S4.55(1A) MODIFICATION STATEMENT

128 Miller Street, North
Sydney

MONTE SANT' ANGELO MERCY COLLEGE

3 December 2021

Figure 3 – Overview of Proposed Modifications

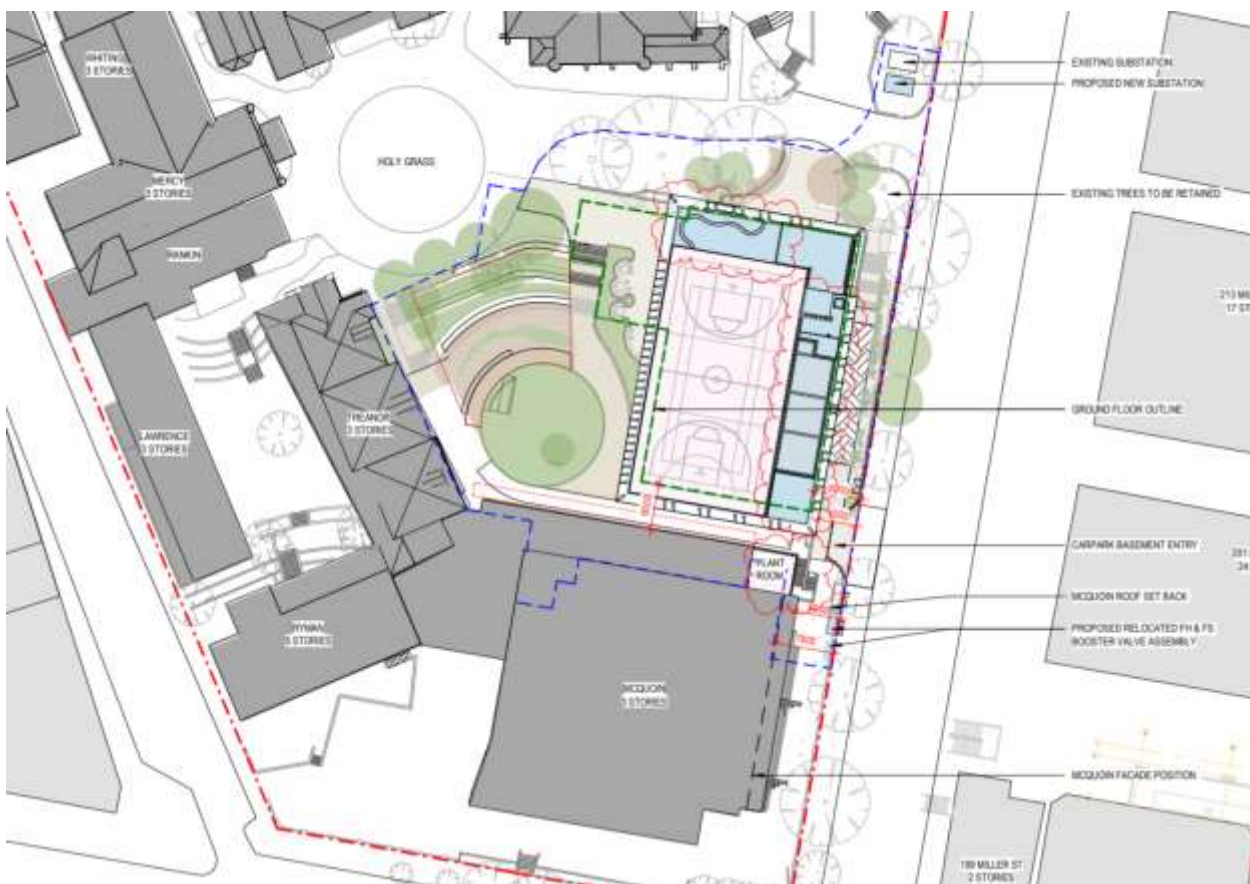
Majority of the proposed changes are internal and considered to be minor. The external changes relate to the design of the rooftop space and the reconfiguration of the mechanical plant room (See **Figure 3**).

A summary of the level-by-level changes to the Scientia Building are described below. Detailed description of the proposed works are contained within the Architectural Statement attached at Appendix B.

Figure 4 – Proposed Miller Street Elevation

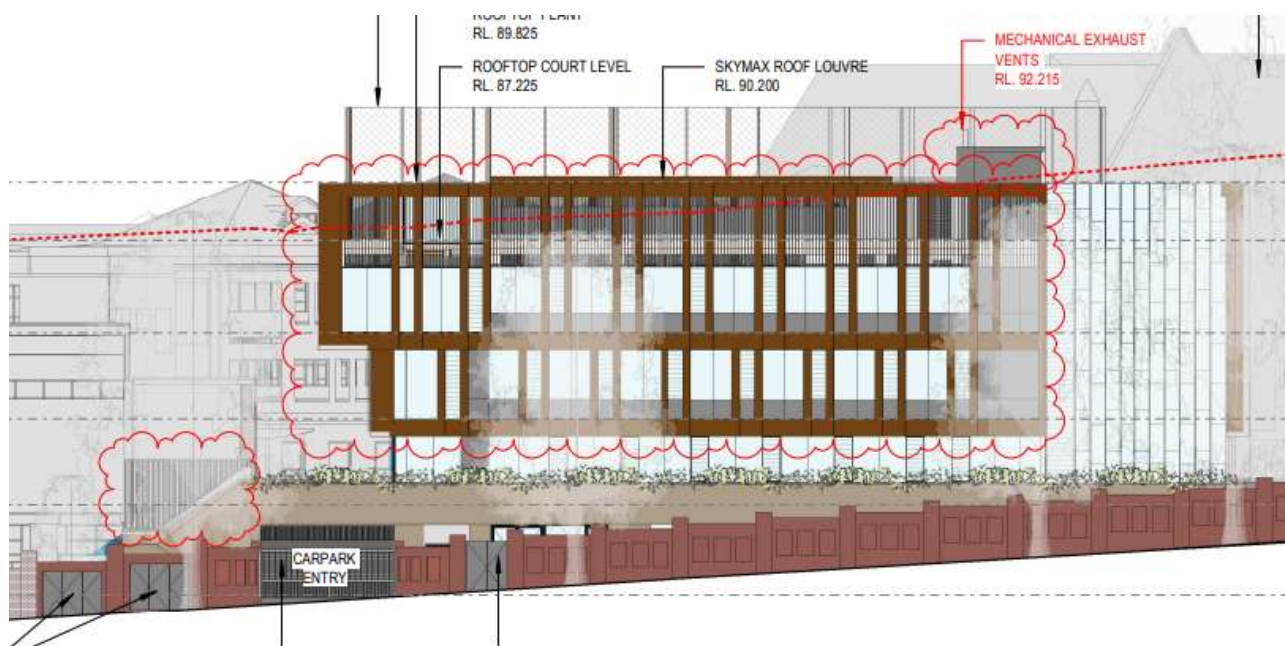
- The proposed plant room is predominantly concealed behind the façade. The exhaust vents project 750mm from the top of the lift shaft. This is required to enable the use of specific chemicals needed for experimentation and to satisfy Australian Standards requirements (refer to mechanical memo attached at **Appendix D**). The height of the vents is below the sport court mesh, which is the highest point of the approved building (refer to **Figure 4**).

Figure 6 – Design Changes to Level 6

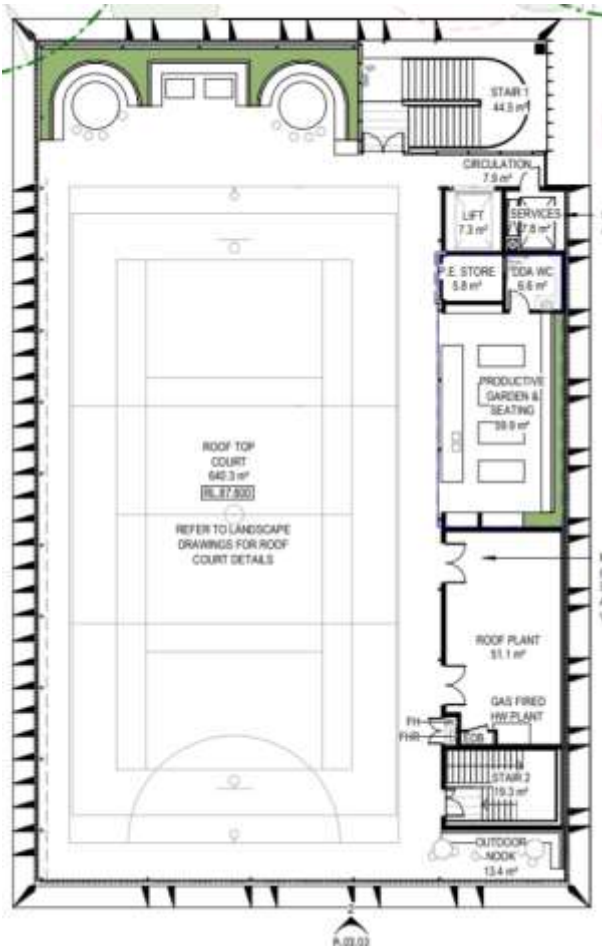
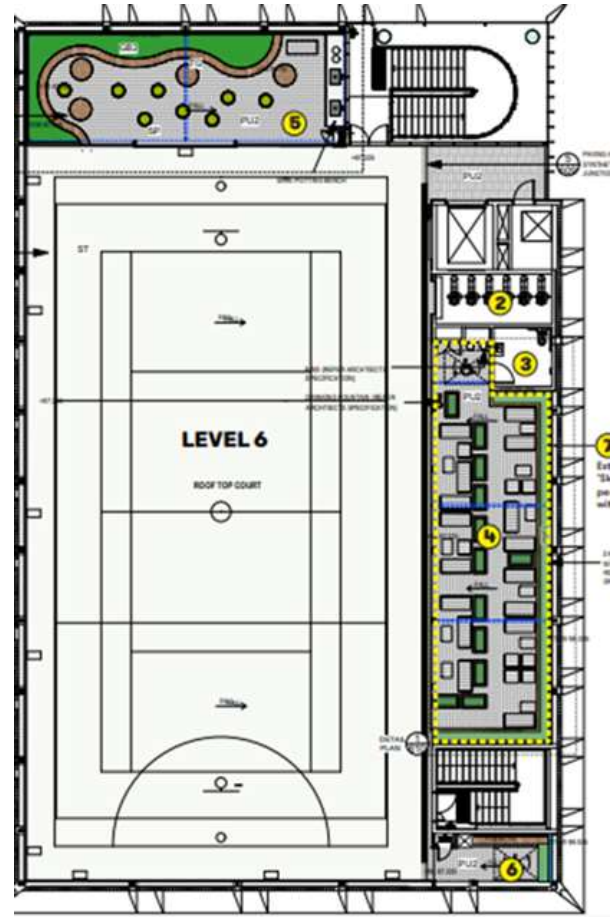
External changes to level 6 rooftop and associated visual impact is assessed below (refer to **Figure 6** and **Figure 7**):

- The proposed plant room is predominantly concealed behind the facade, however a small portion extends the sight line of the lift core as seen in the eastern elevation. This small portion relates to the exhaust vents, which project 750mm from the top of the lift shaft. This minor protrusion is below the sports court mesh height and will be screened by trees when viewed from Miller Street (refer to **Figure 8**). Therefore, the proposal has been designed to minimise visual impact from both within the school and from Miller Street.

- The materiality of the modified plant room will be consistent with what was previously approved, utilising Barestone cladding, keeping the same visual outlook.

- Proposed rooftop lounge area and social space have significantly increased in size, providing more amenity to staff and students and more greenery along Miller Street. The enlarged area will not only improve outdoor learning facilities, more importantly, the additional edge planting will improve visual outlook from Miller Street. Overall, the social space changes will create a positive impact on the visual quality of the building.

- The south-east corner of the rooftop will be enclosed with a roof to enable storage of sports equipment. The roof will be in line with the facade and not visible from the street.

- The specification for the rooftop pergola has been revised from a 'Webnet' metal mesh pergola to a 'Skymax' louvred pergola system. The pergola on the northern portion of the roof has been deleted. The pergola on the eastern portion of the rooftop has been extended over the revised Social Space. When compared to the approved, the proposed changes to pergola will create greater aesthetic quality and will not have any material visual impact to the streetscape.

Figure 7 – Proposed Modification to Elevations

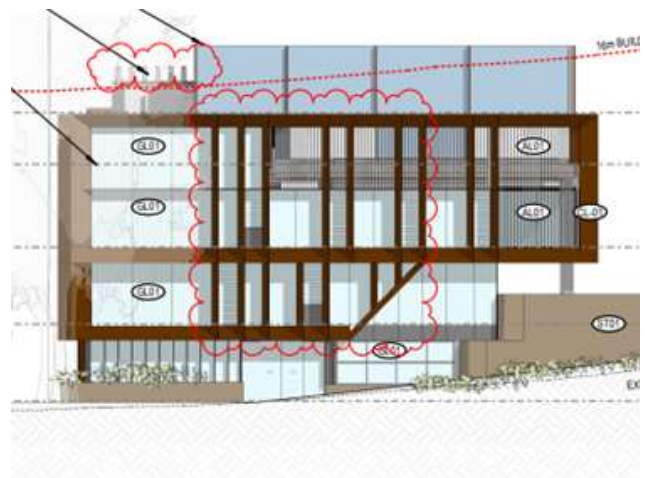
The majority of changes proposed for the Scientia Building are internal. External changes mainly relate to rooftop redesign and minor façade amendments, which apply to the eastern, southern and northern elevation. Elevation comparison plans is provided in **Figure 7**.
